TEMPORARY DRAINAGE PROPOSAL

APPLICATION SITE OF THE PROPOSED
TEMPORARY PLACE OF RECREATION, SPORTS OR
CULTURE (HOBBY FARM) FOR A PERIOD OF 3
YEARS AT LOTS 1430 (PART), 1431 (PART), 1439
(PART) AND 1440 (PART) IN D.D.114, SHEK
KONG, YUEN LONG, NEW TERRITORIES

APPLICATION NO. A/YL-SK/359

Response to Comments on Temporary Drainage Proposal

Appendix C -
Proposed Drainage Plan

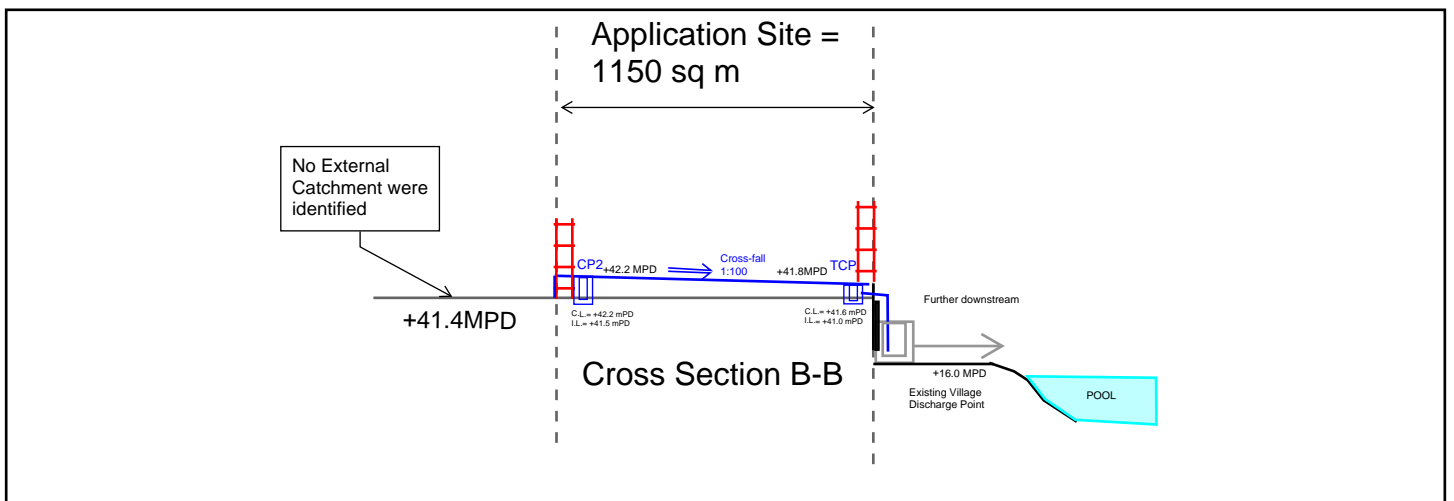
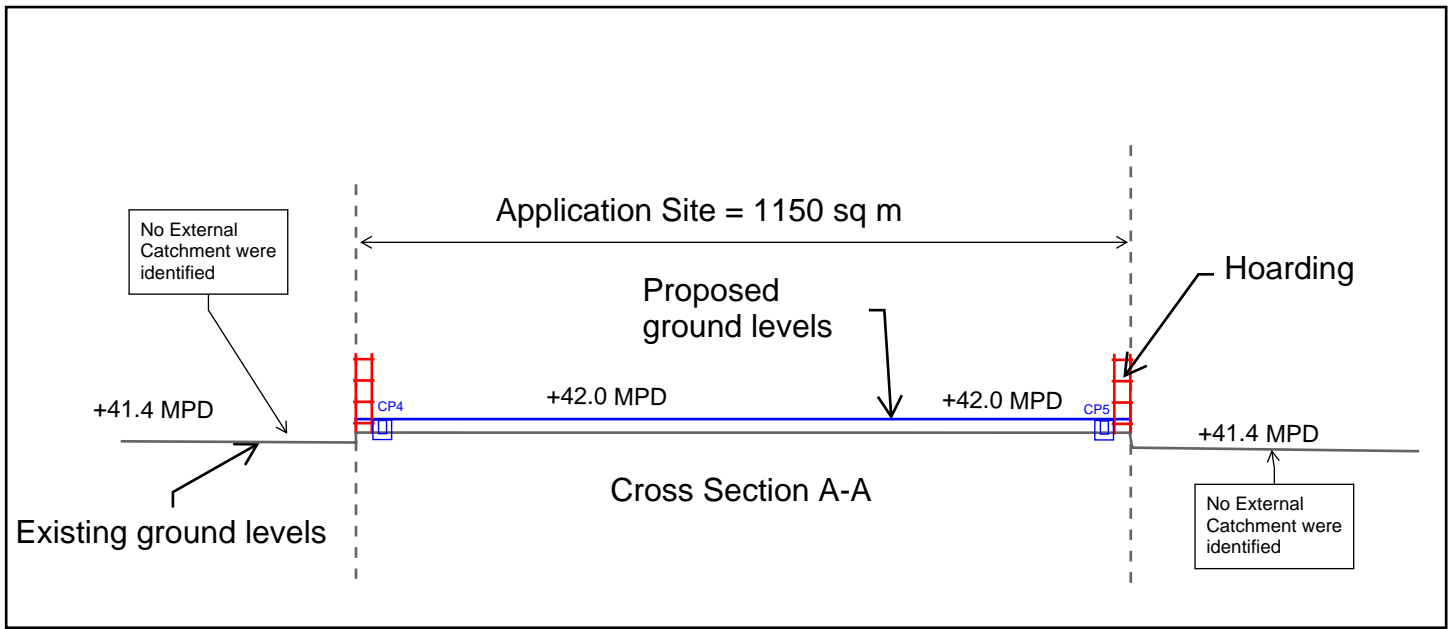
5.	Please indicate clearly the full alignment of the discharge path from the application site all the way down to the ultimate discharge point (e.g. a well-established stream course/public drainage system).	For the full alignment of the discharge path from the application site, please refer to the Appendix C – Proposed drainage plan.

6.	The gradients of the proposed U-channels should be shown on the drainage plan,	Noted and provided. Please refer to Appendix C - Proposed drainage plan.

7.	The proposal should indicate how the runoff (the flow direction) within the site would be discharged to the proposed u-channel.	Noted and provided. Please refer to Appendix C - Proposed drainage plan.

8.	The cover levels and invert levels of the	Noted and provided. The invert levels,

9.	Cross sections showing the existing and proposed ground levels of the captioned site with respect to the adjacent areas should be given.	Noted and provided. Please refer to Appendix C - Proposed drainage plan.

10.	Sand trap or provision alike should be provided before the collected runoff is discharged to the public drainage facilities.	Noted. Terminate catchpit with Sand traps is to be provided before discharging to the downstream village drainage facilities, to prevent blockages and for regular maintenance purpose. Please refer to Appendix C - Proposed drainage plan.

APPENDIX D
DESIGN CALCULATION OF THE PROPOSED DRAINAGE

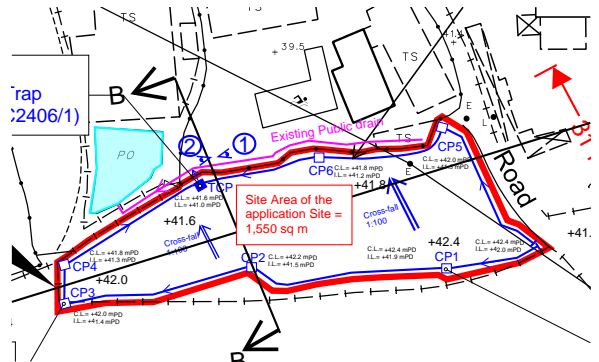
2.	Please demonstrate with hydraulic calculation that the proposed drainage facilities are adequate to collect convey and discharge the surface runoff accrued on the application site and the overland flow intercepted from the adjacent lands.	Noted and provided. Please refer the captioned Temporary Drainage Proposal (Issue 2) and the hydraulic calculation in the Appendix D for your consideration.

APPENDIX E

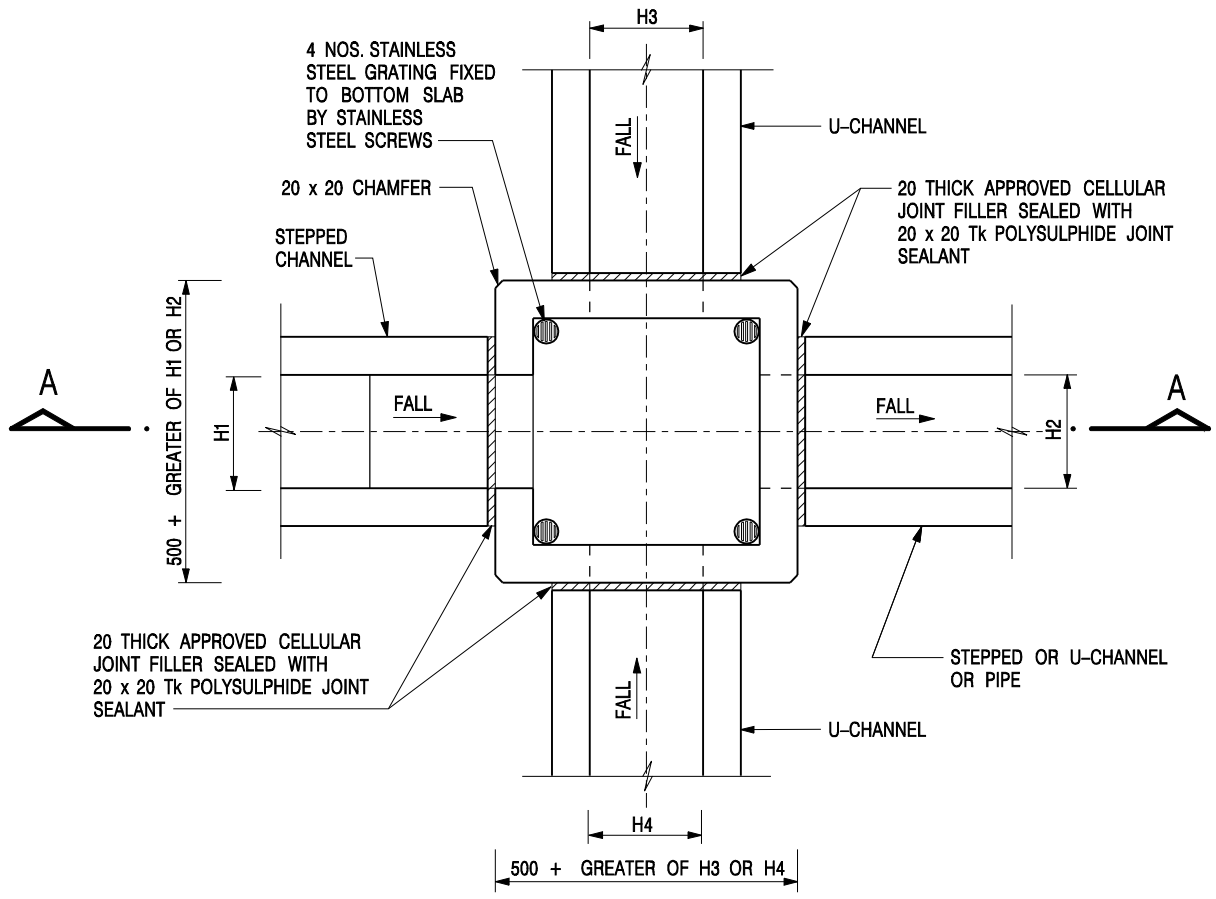
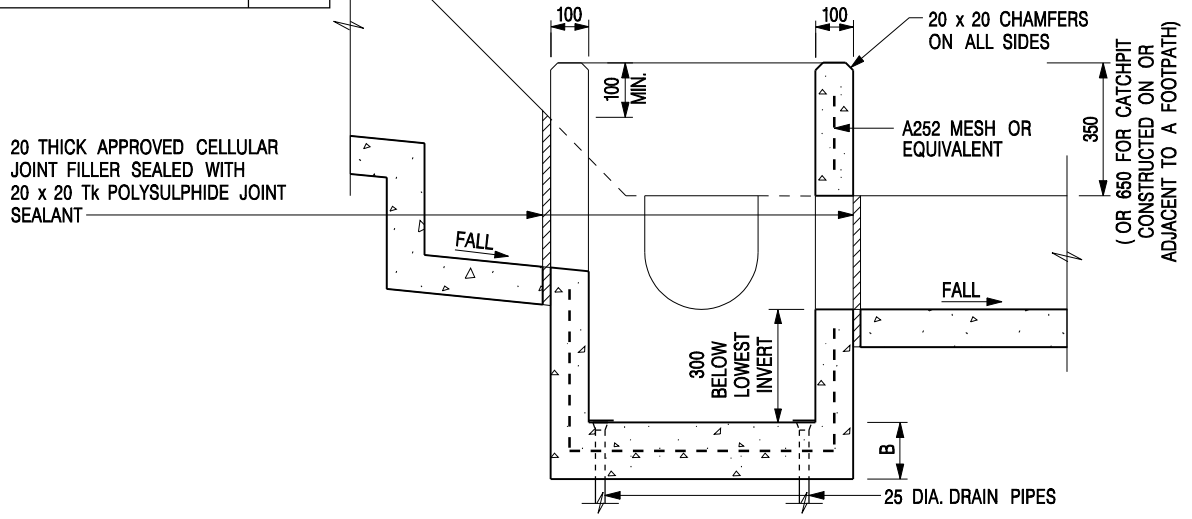
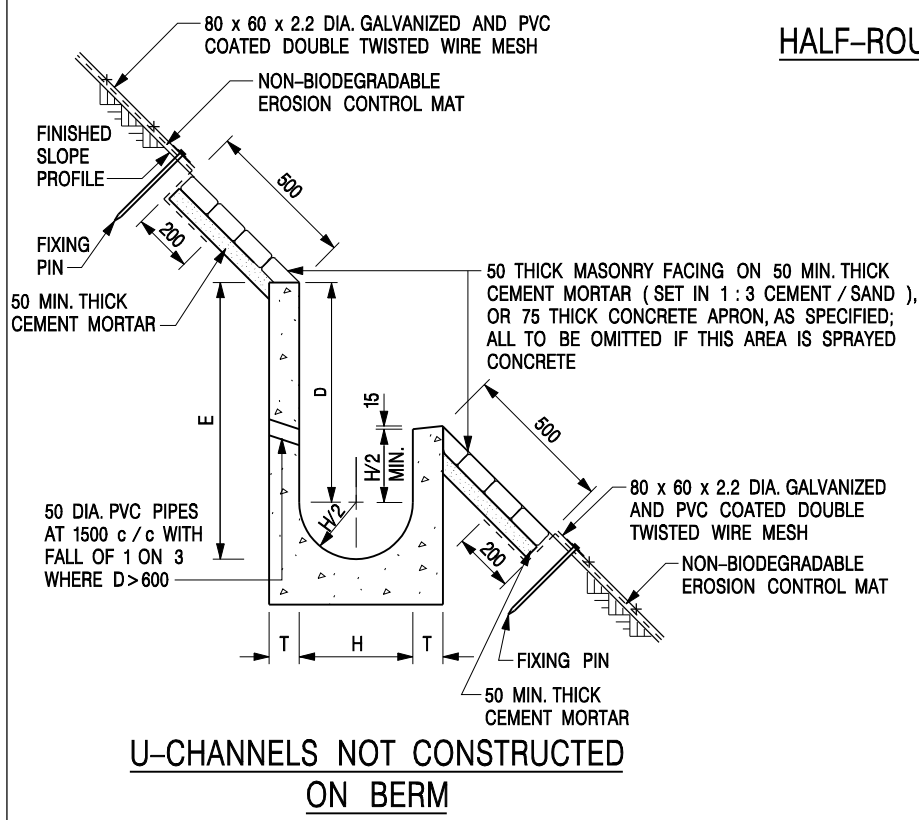
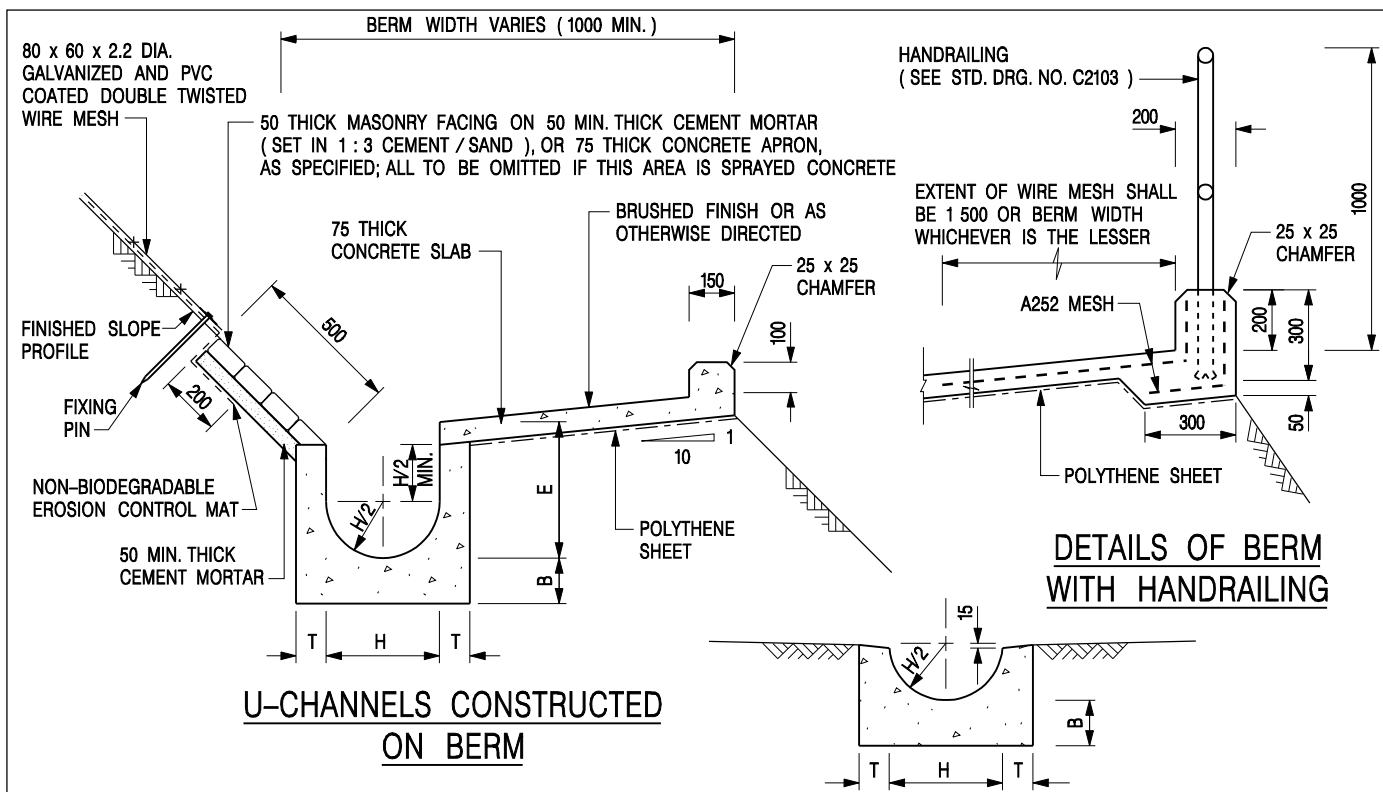
11.	Standard details should be provided to indicate the sectional details of the proposed u-channel and the catchpit/sand trap.	For the Standard details, please refer to the Appendix E - Typical Standard Drawings of U-Channel and Catchpit.
